# SERVICE LETTER

No. 883

Piper Aircraft Corporation

Subject: Wing Flap Rivet Installation

BOTTOM VIEW OF LEFT FLAP SHOWN — RIGHT FLAP OPPOSITE

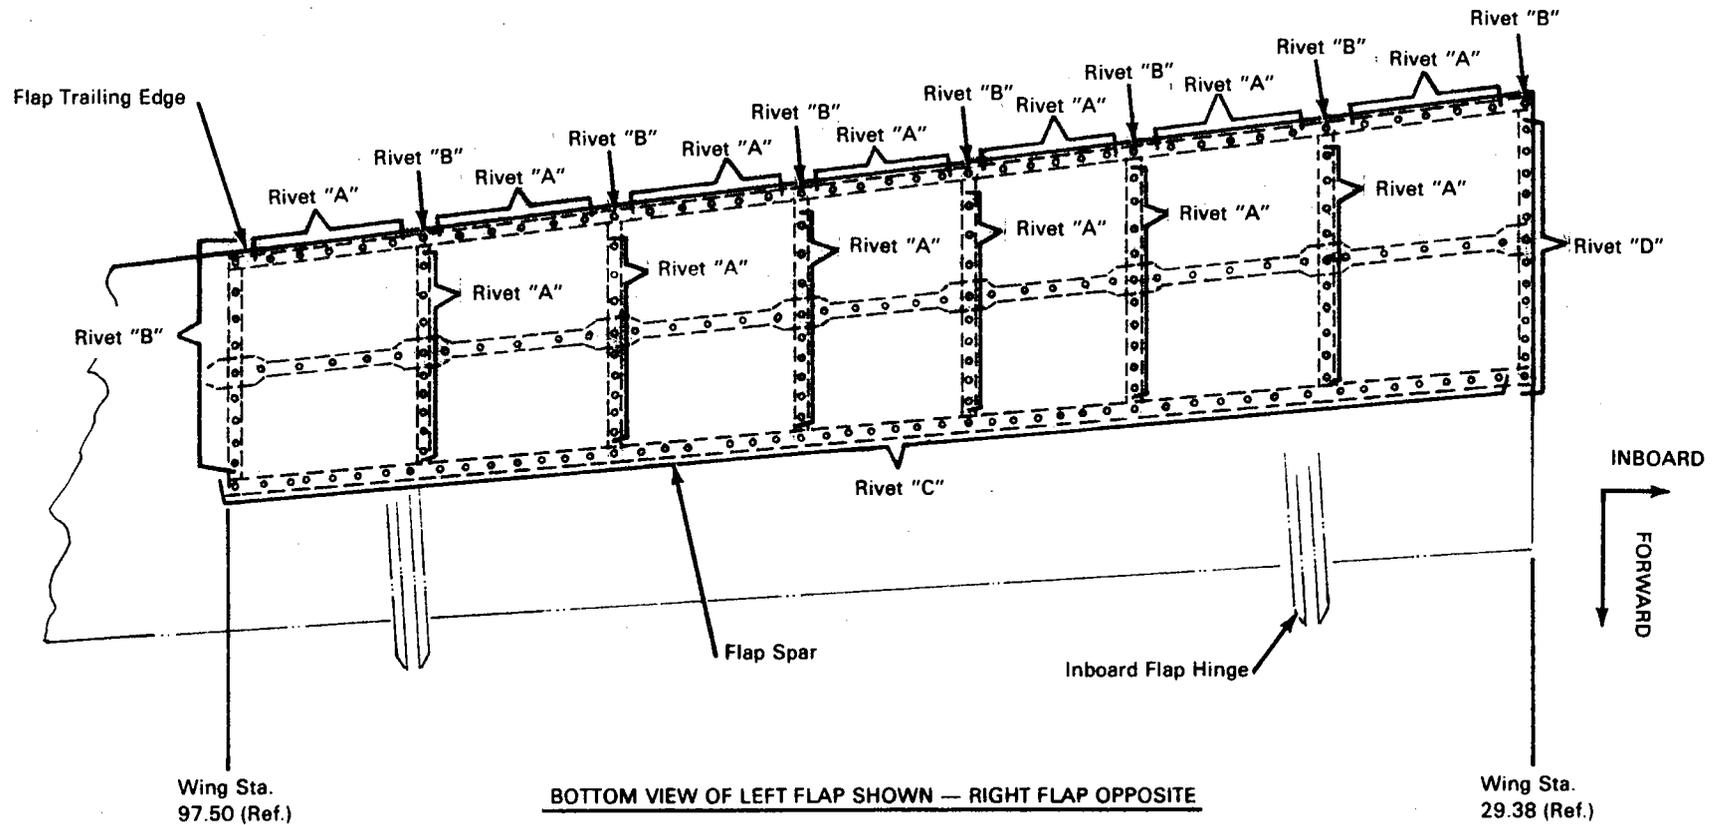
Reports have been received of loose rivets on the bottom surface of the wing flap assemblies. In several instances recurrent loosening of rivets has occurred in aircraft on which loose rivets were replaced.

This Service Release provides instructions for the replacement of loose rivets and the installation of additional rivets on the bottom surfaces of the wing flap assemblies.

1. Gain access to the bottom surfaces of the left and right wing flap assemblies.
2. Replace any rivets showing evidence of looseness. Refer to sketch for proper replacement part.
3. On the bottom surfaces of the wing flap assemblies, from and including Wing Station 29.38 to and including Wing Station 97.50 between the flap trailing edge and the flap spar including the flap spar, add appropriate rivets midspace between existing rivets where the distance between the existing rivets is one (1) inch or greater.
4. Make proper log book entry of compliance with this Service Release.

Rivet NAS1738B-4-1 (Piper Part No. 522 881)  
Rivet NAS1738B-4-2 (Piper Part No. 522 882)  
Rivet NAS1738B-4-3 (Piper Part No. 522 883)  
Rivet MS20470AD3-3 (Piper Part No. 420 200)
